Breakwater extension, Northern Harbour Precinct, Jervoise Bay

Department of Commerce and Trade

**Report and recommendations
of the Environmental Protection Authority**

**Environmental Protection Authority
Perth, Western Australia
Bulletin 836
December 1996**

Figure 2. Development Plan — Breakwater extension, Northern Harbour Precinct, Jervis Bay (Source: Halpern Glick Maunsell, 1996).

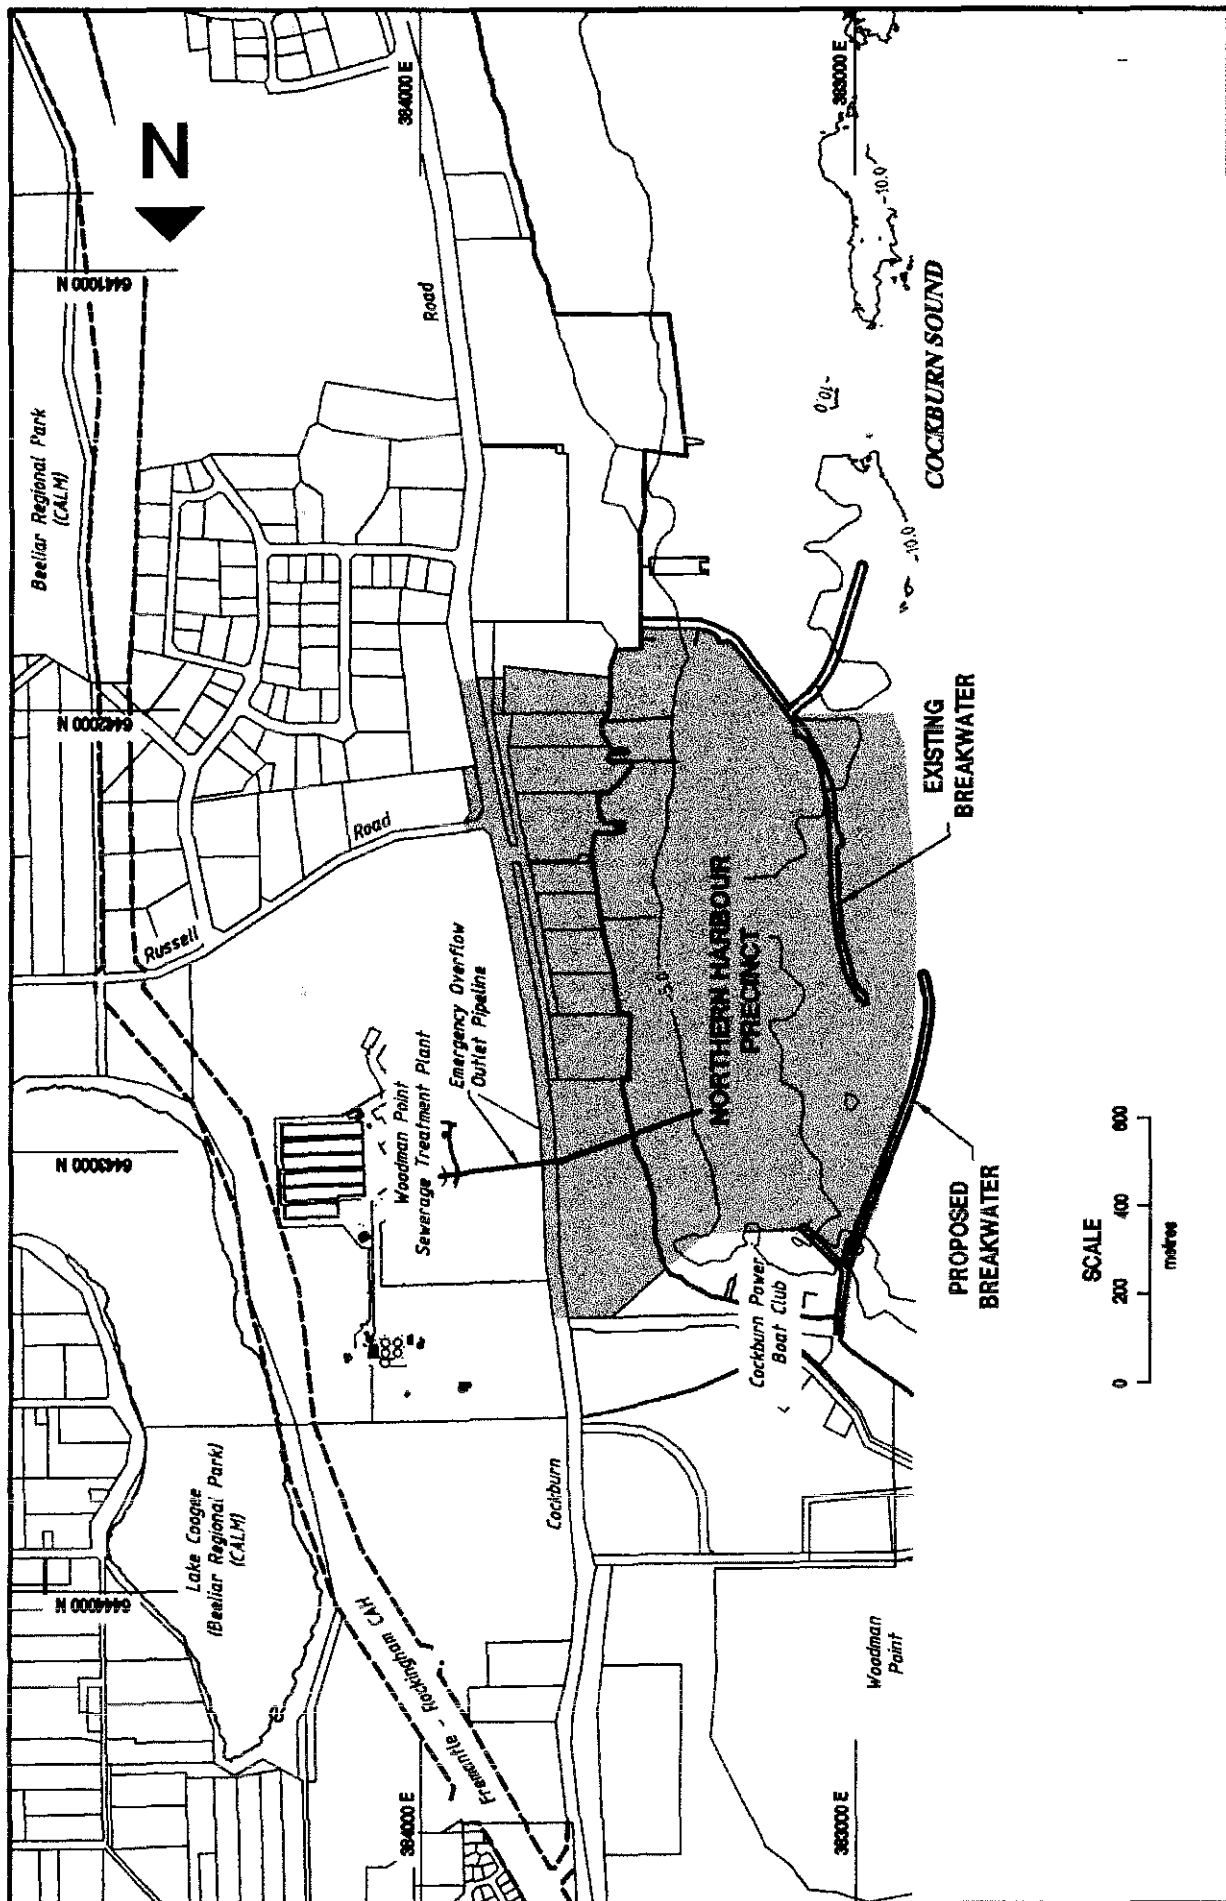
The present harbour is closed to the south by an existing breakwater. The water exchange between this harbour and Cockburn Sound takes place through the northern opening (Appendix 1: Figure 1). The proposed extension of the breakwater (Appendix 1: Figure 2) will significantly reduce the cross sectional area of the opening between the harbour and Cockburn Sound. This will decrease the flowrate through the opening and conversely increase the time taken to exchange the equivalent water volume of the harbour with Cockburn Sound water.

The area considered for assessment of this relevant factor marine water and its quality is the area of the proposed harbour itself (Appendix 1: Figure 2). This is the area over which the proposal may affect on marine water quality.

The predictions of the volume exchange through the harbour opening (Appendix 1: Figure 2) and the estimated flushing time have been determined (Halpern Glick Maunsell, 1996). These estimates show that equilibrium nutrient concentration is expected to increase in the order of only 5% (on average) and that the worst case maximum increase would be 23%. These estimates have been based on very rudimentary first order equilibrium models and the confidence or uncertainty in these results is considered accordingly.
